**RE: Paradise Subdivision
Grading and Drainage Plan
Engineer's Stamp Date: 11/17/21
Hydrology File: B11D014**

Based upon the information provided in your submittal received 11/24/2021, the Grading & Drainage Plan **is not** approved for Grading Permit and for action by the DRB on Preliminary Plat. The following comments need to be addressed for approval of the above referenced project:

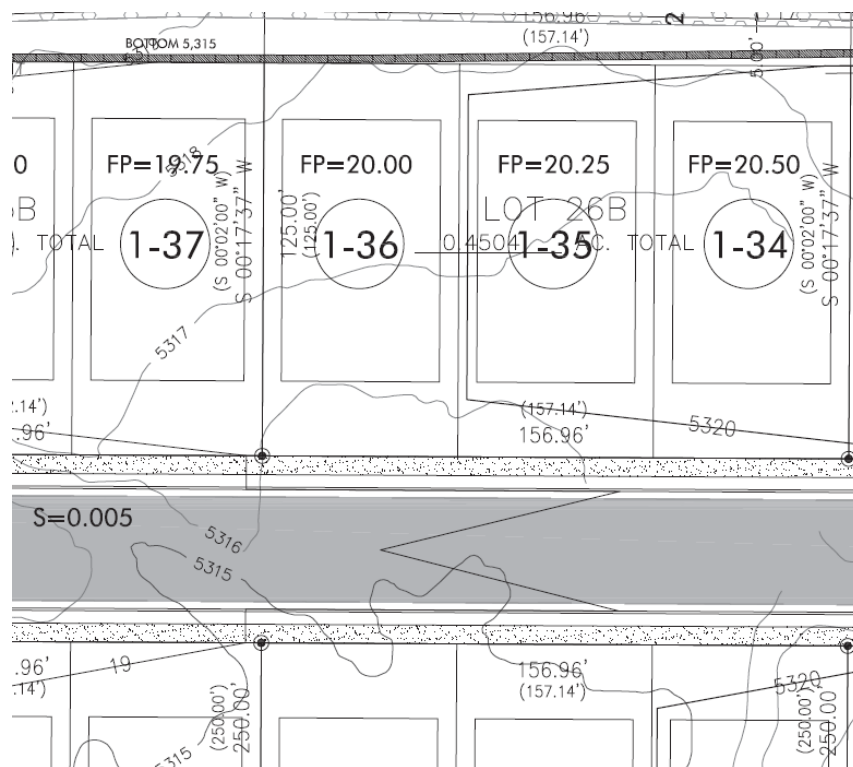
- Please provide for a Legend. Here are some examples.

- Your Grading Plan is missing typical grades that are needed in order to review and approve this project.

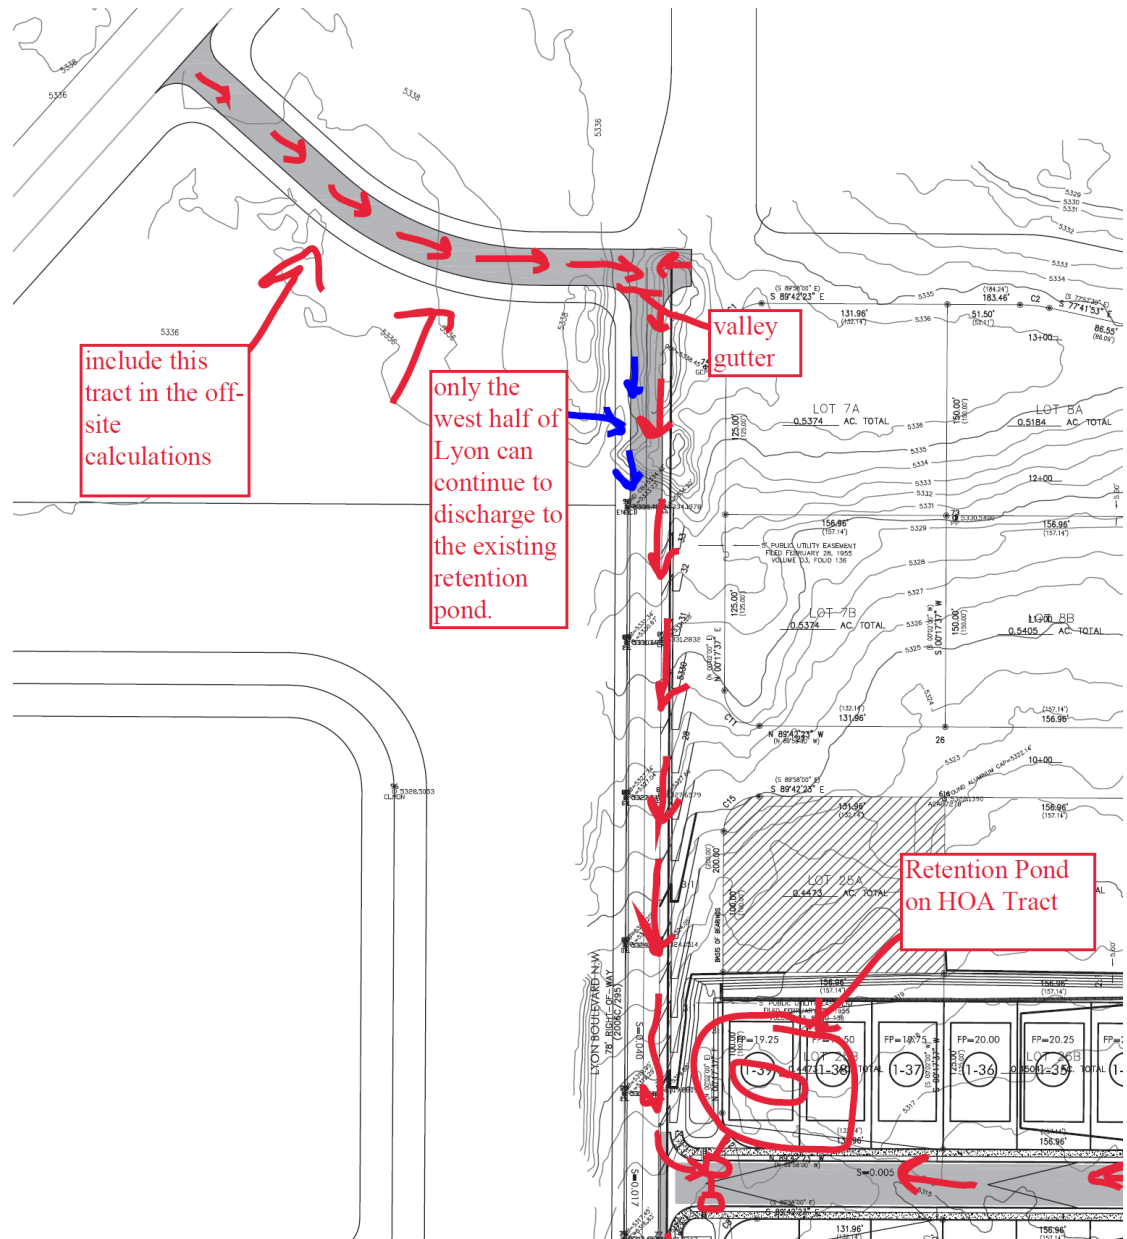
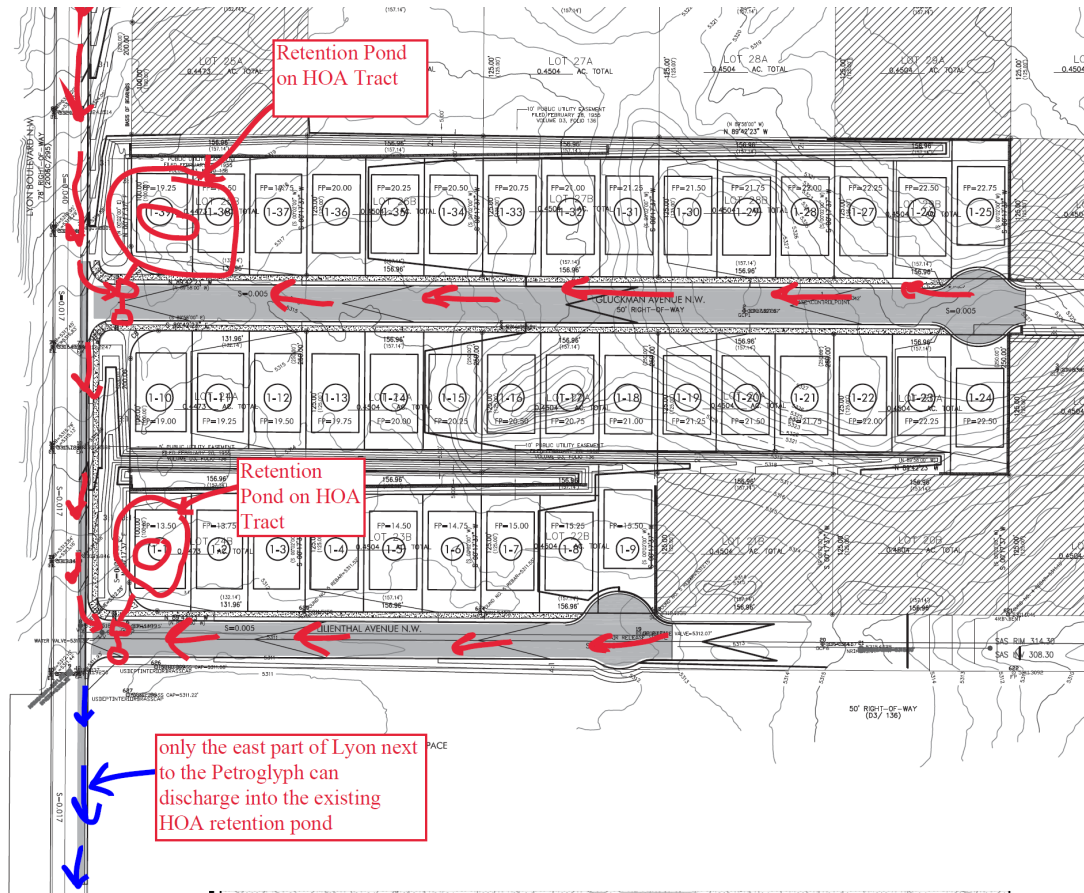
5. For Subdivisions and especially for this one, please provide a Drainage Repot. Within this report, I will need Drainage Basin for the project and the off-site drainage. I will also need street capacity calculation for all public R.O.W. being constructed.
6. All drainage from the public R.O.W. and single family lots will have to drain into a public retention pond (100 year – 10 day volume) on a HOA owned tract. This pond will also need to provided for a maintenance ramp, gate, and an Agreement & Covenant will also need to be filled for the pond. This retention pond cannot be placed on the single-family lots. There is a current drainage basin on Blue Feather & Lyon. However, this retention pond was only sized for the following drainage basin.

The Proposed drainage needs to be directed as shown into proposed inlets & pipe into a retention pond on an HOA Tracts as shown. The blue drainage arrows are areas that may

discharge into the existing retention pond if the current HOA that owns and maintains it agrees to accept the minimal increase in drainage.

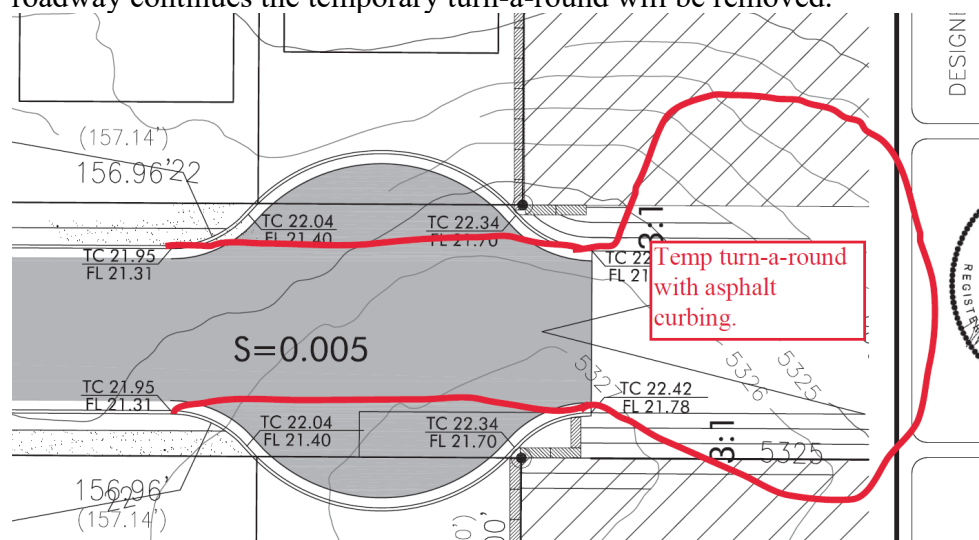
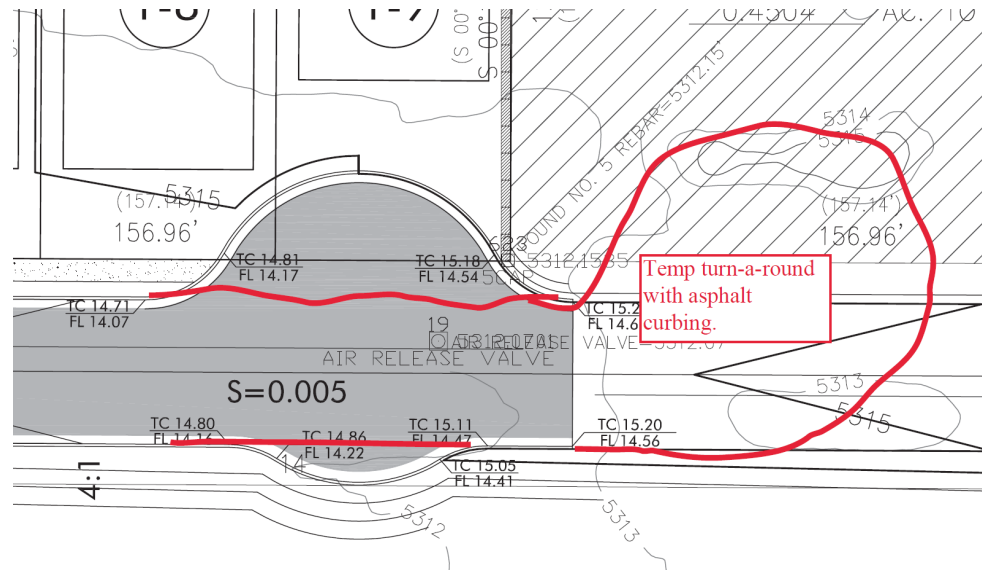
7. It appears that both temporary cul-de-sacs are not designed to City standards. Please verify.
8. Also, the temporary turn-a-rounds are placed as shown so that once the subdivision's roadway continues the temporary turn-a-round will be removed.

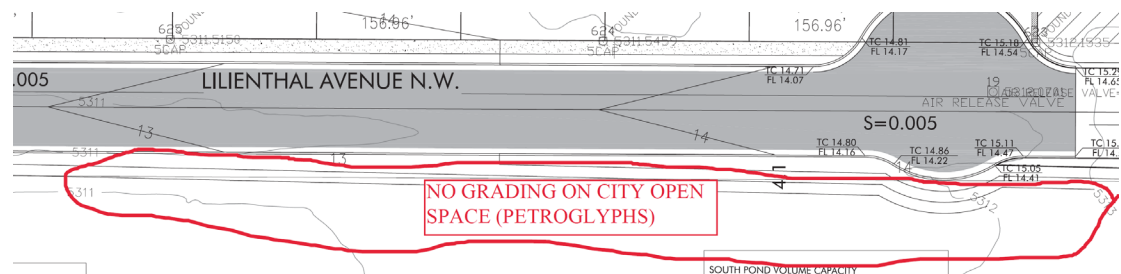
9. There will be **no grading** on City of Albuquerque Open Space (Petroglyphs).
